802.3CG T1S MULTIDROP TERMINATIONS

802.3cg Short-Reach PHY

Multidrop Terminations

Figure 147-10—Multidrop line termination and PMD

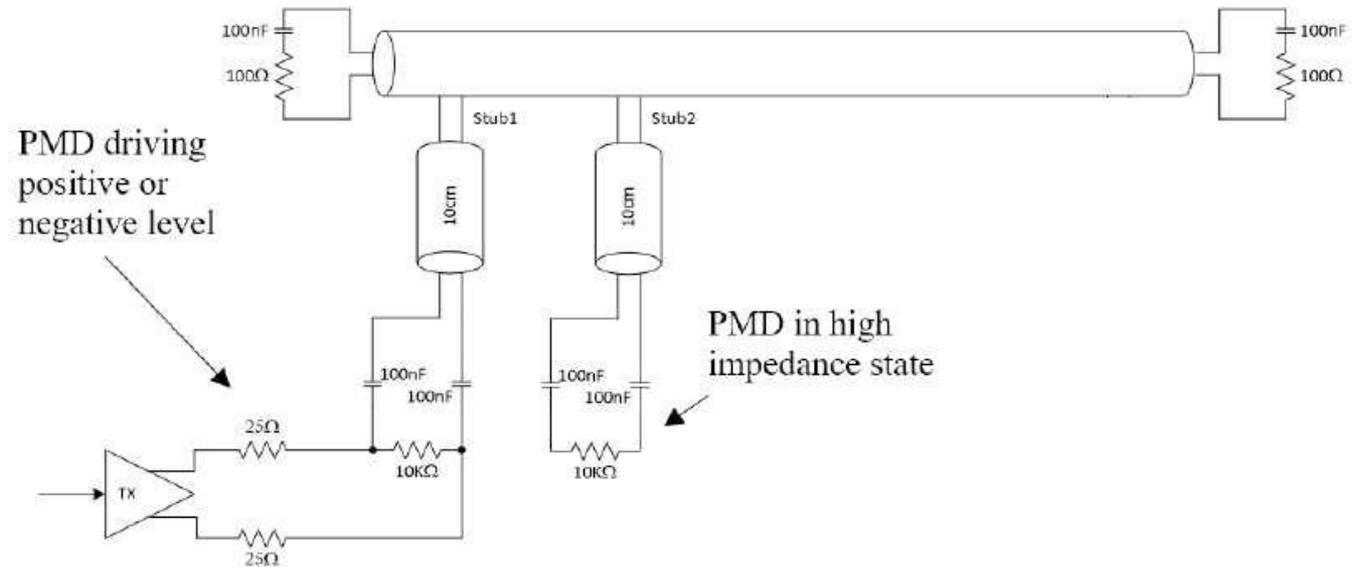
■ Problems:

- End node terminations can be required to be active nodes (T1S PHYs) in Automotive application
- Stub transceiver termination does not need to be specified for system to work, but (the current) specification precludes certain implementations

Proposal for Subclause 147.5.1.2 („PMD Specifications for multidrop mixing segment“)

- „If PHY is configured as a head node, the PMD shall provide 100Ohm +- 30% resistive termination.“
- „If PHY is configured as a stub node and is not transmitting, PMD shall go into high impedance state.“
(value as per comment on Draft 1.0 „10kOhm or larger from 0 to 25MHz“)
- Advantages of this specification:
 - all cases work through configuration
 - Multidrop with active end nodes
 - Multidrop with passive end nodes
 - point-2-point can also be configured
 - certain stub transmitter implementations are not precluded
